**RE: Application ID #: 2-6304-01724/00001**  
**By CSC 4540 LLC**  
**To Replace the Existing Deteriorated Timber Bulkhead at the Southeastern Corner of**  
**Anable Basin in Long Island City, Queens County, NY**

We are hereby submitting revised drawings to address the Notice of Incomplete Application (NOIA), dated October 23, 2015. Section 01.1 of this package contains itemized responses to all NOIA comments; in this section, each of the comments from the notice is reproduced in italics with our responses directly following.

## 01.1 NYSDEC "Notice of Incomplete Application" Responses

#### Fill Calculations

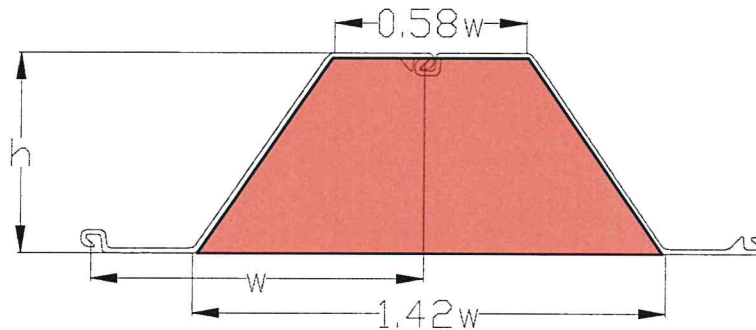
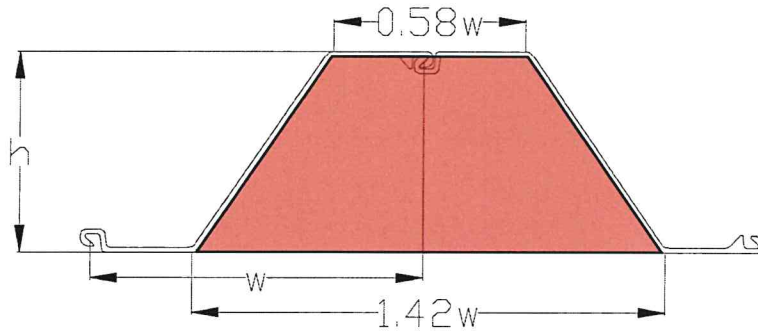
3. *"The applicant must propose mitigation for the 24 cubic yards of fill (bulkhead and backfill) that will be placed within 73 square feet of tidal wetlands. For this type of project, the Department prefers fill removal in order to create new tidal wetlands at a 2:1 ratio."*

If the proposed sheet-pile bulkhead is placed directly against the seaward face of the existing bulkhead along the southern-most edge of Anable Basin, then approximately 221 cubic feet (8 cubic yards) of backfill will be required below MHW along the 40± linear feet of bulkhead. It is important to note that where backfill is necessary, only clean backfill will be used. Required fill volume can be calculated as follows:

Including the 3.5" average gap between the existing and proposed bulkheads:

If the proposed sheet-pile bulkhead is placed directly against the landward face of the existing bulkhead along the eastern-most edge of Anable Basin, then approximately 986 cubic feet (36 cubic yards) of backfill will be mitigated below MHW along the 77 linear feet of bulkhead. Mitigation volume can be calculated as follows:

**R-4.1**

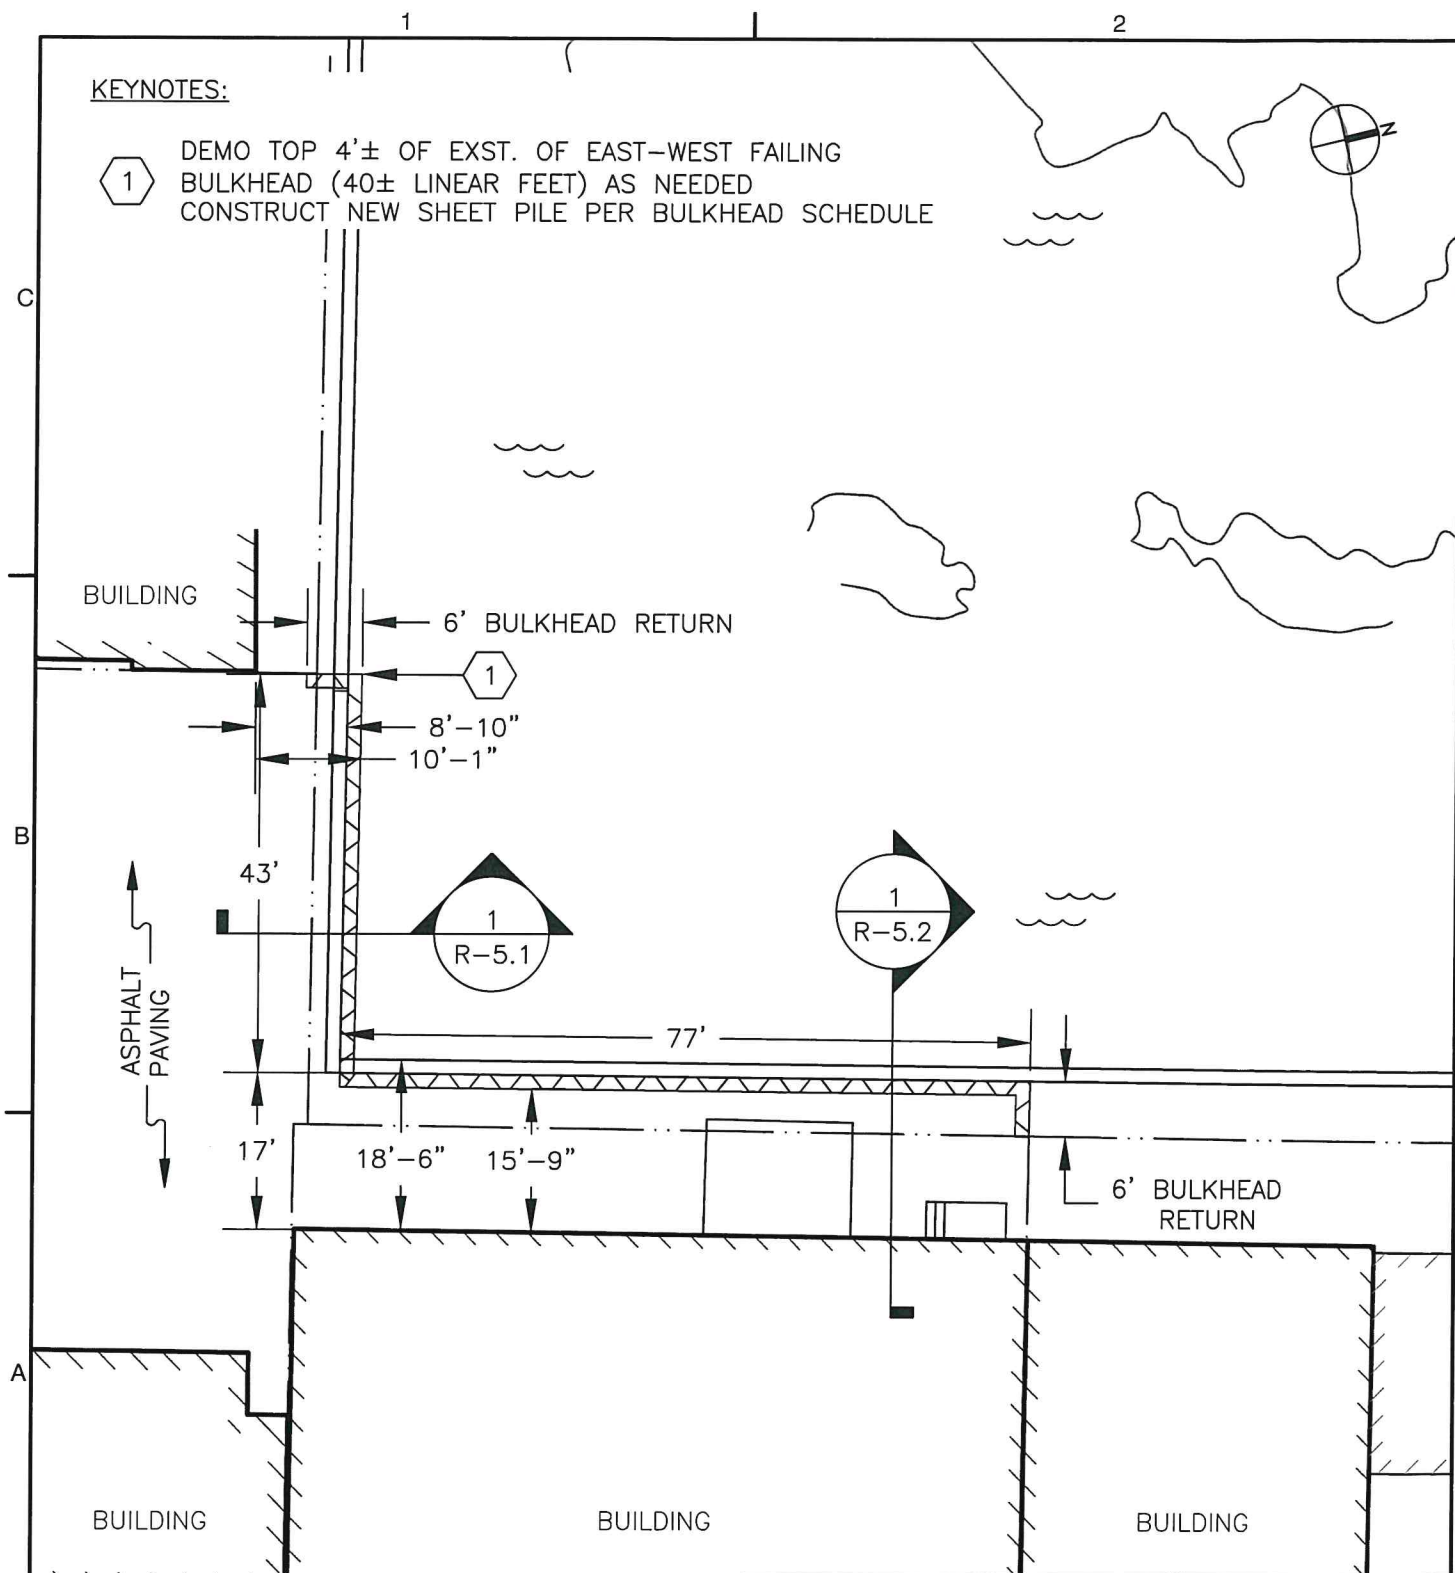
1. *"Provide measurements from the seaward face of the proposed bulkhead to a fixed permanent structure (such as the seaward face of a building) on the following plans: R-5.1, R-6.1 to R-6.7. Some plans show the measurement from the landward face of the bulkhead; however, the measurements should be taken from the seaward face."*

Measurements from the seaward face of the proposed bulkhead to a fixed permanent structure are provided on all specified revised drawings, including R-4.1 (Proposed Site Plan), R-5.0 (Section Plan), R-5.1 through R-5.2 (Sections) and R-6.1 through R-6.7 (Sections).

**R-5.1**

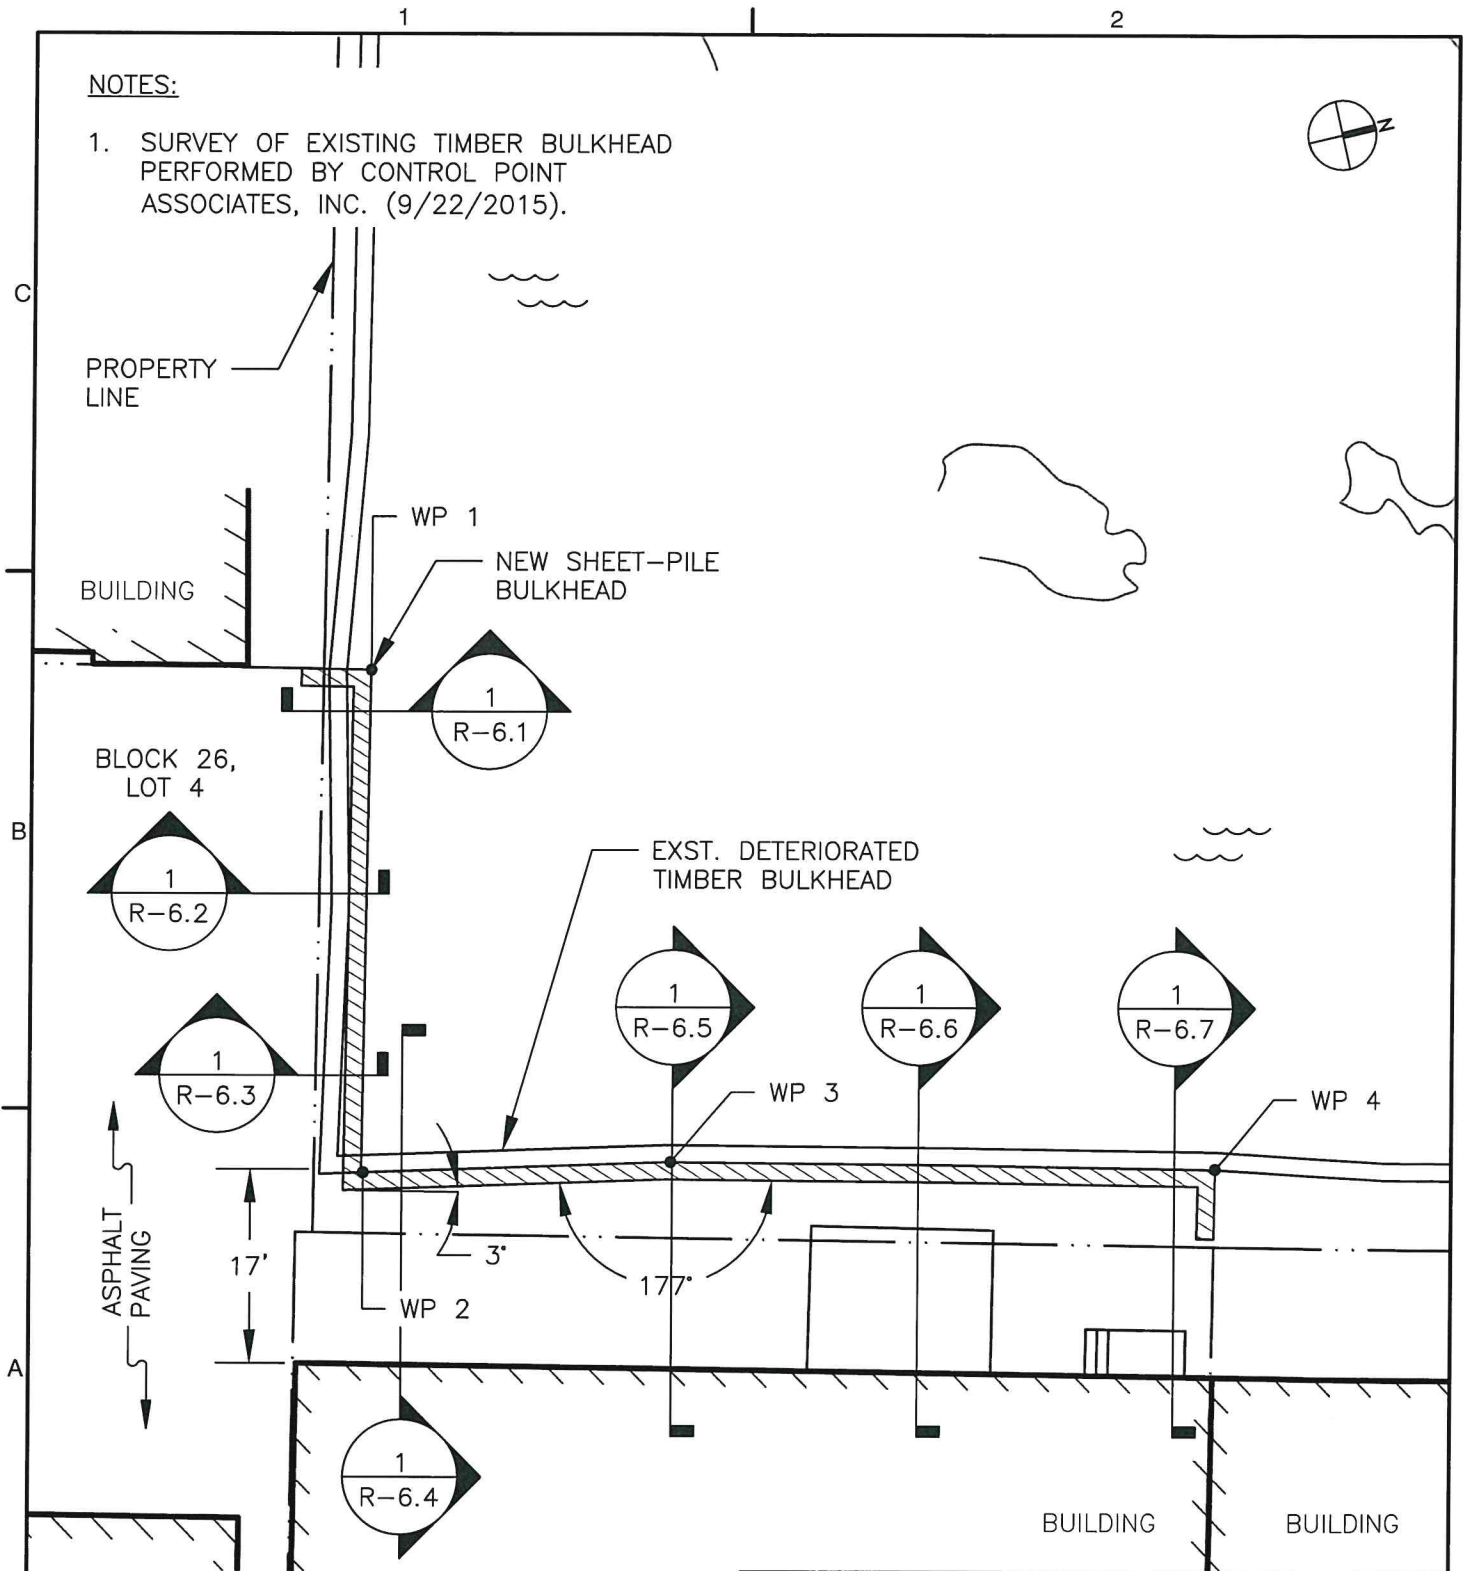
2. *"Please submit cross sections of existing conditions that correspond to the previously submitted proposed cross sections (R-5.1, R-5.2, R-6.1 to R-6.7). Both existing and proposed cross sections should show the distance from the seaward face of the bulkhead to the same fixed permanent structure."*

Both existing and proposed cross sections are shown in all specified revised drawings, including R-5.1 through R-5.2 (Sections) and R-6.1 through R-6.7 (Sections). The existing bulkhead is indicated with a dashed line in these sections. Measurements from the seaward face of the proposed and existing bulkhead to a fixed permanent structure are provided on these sections.
